2CAN010205

January 31, 2002

Subject: Arkansas Nuclear One - Unit 2  
Docket No. 50-368  
License No. NPF-6  
Response to Follow-up Request for Additional Information Concerning SGTR  
and MHA Dose Assessment Calculations Supporting ANO-2 Power Uprate

Figure1  
Containment Building Looking North

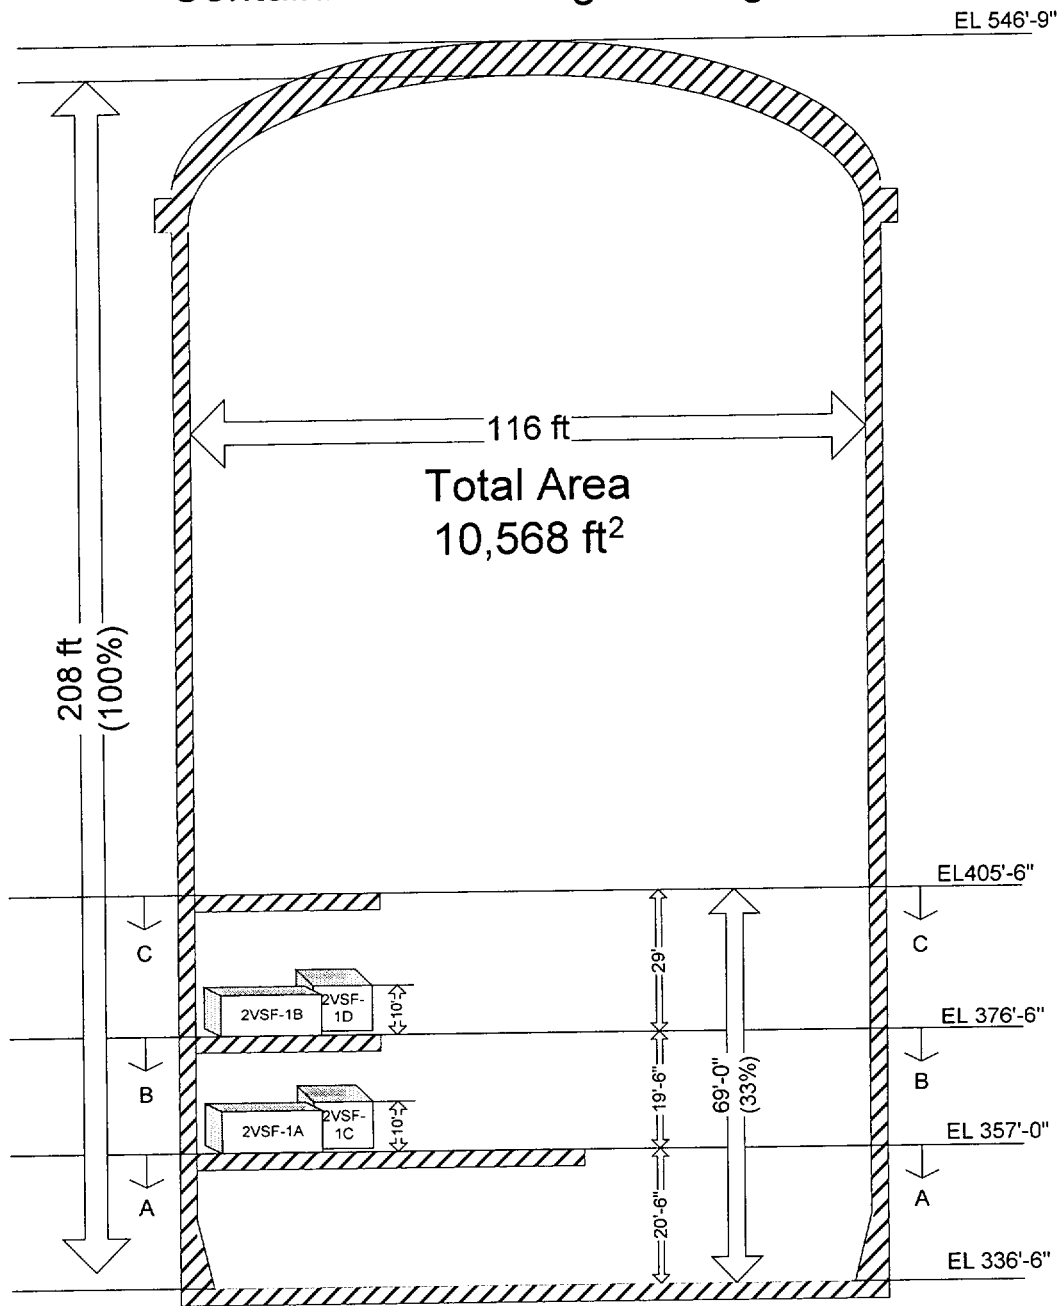
The staff has reviewed the Safety Analysis Report (SAR) to determine if the SAR contains additional information to justify assuming that the air taken from the unsprayed region of the containment by the containment air coolers will only be replaced by air entirely drawn from the sprayed region. A review of Chapter 6 and Figure 9.4-4 provides insufficient information for the staff to conclude that the containment air coolers are drawing 78% of their air from the sprayed region and the remainder from the unsprayed region and that the air returned to the unsprayed [region] is entirely from the sprayed. Please provide additional details on the operation of the containment air coolers to justify the mixing assumptions in the maximum hypothetical accident (MHA) calculations.

"Good communication volumes" are those judged to readily mix with the sprayed regions. For example, the polar crane consists of a trolley and two girders. The trolley, at elevation 506' is approximately 17' by 12' or  $204 \text{ ft}^2$ . This area is extended downward for 149 feet to elevation 357' for a projected unsprayed volume of  $30,396 \text{ cubic feet } (\text{ft}^3)$ . In the same manner, the two girders, which are broken into sections because of several different lower obstructions, form a series of projected areas of rectangular cross-sections extending downward 139', 91', 68', 131' and 134'. The girders form total projected unsprayed volumes of  $82,200 \text{ ft}^3$ . Therefore, the polar crane and its girders together account for  $112,596 \text{ ft}^3$  or over 43% of the "good communication" unsprayed volume. Figure 1 is a simplified sketch that shows dimensions and proportions of the containment building.

Figure 1 provides a simplified elevation view of containment. The overall inside height is 208' and the inside diameter is 116'. As indicated on the sketch, the lower 1/3 of containment has three approximately equally spaced elevations composed of a combination of grating walkways and concrete slabs. The upper 2/3 of the structure is largely but not completely open. Most, but not all, of the "good communication" volumes are within the upper two-thirds of containment. All of the "not good communication" volumes are in the bottom one-third. Figure 2 is a plan view of section A-A at elevation 357'-0"; Figure 3 is a plan view of section B-B at elevation 376'-6"; and Figure 4 is a plan view of Section C-C at elevation 405'-6".

As shown on Figures 1 and 3, containment air coolers 2VSF-1B and 2VSF-1D are anchored to the northwest slab at elevation 376'-6". Coolers 2VSF-1A and 2VSF-1C are anchored directly below the upper coolers to the elevation 357'-0" slab. Therefore, the slab in Figure 3 shows that the elevation 405'-6" northwest slab provides roofing over the upper coolers and the elevation 376'-0" slab is a roof to the lower coolers. The Section C-C slab has an area of 800 ft<sup>2</sup>. The slab in the Section B-B that is the roofing over 2VSF-1A and 2VSF-1C is also approximately 800 ft<sup>2</sup>. The containment air coolers each have a cross-sectional area of 200 ft<sup>2</sup>. With two air coolers on an elevation, the cross-sectional area is 400 ft<sup>2</sup> per elevation.
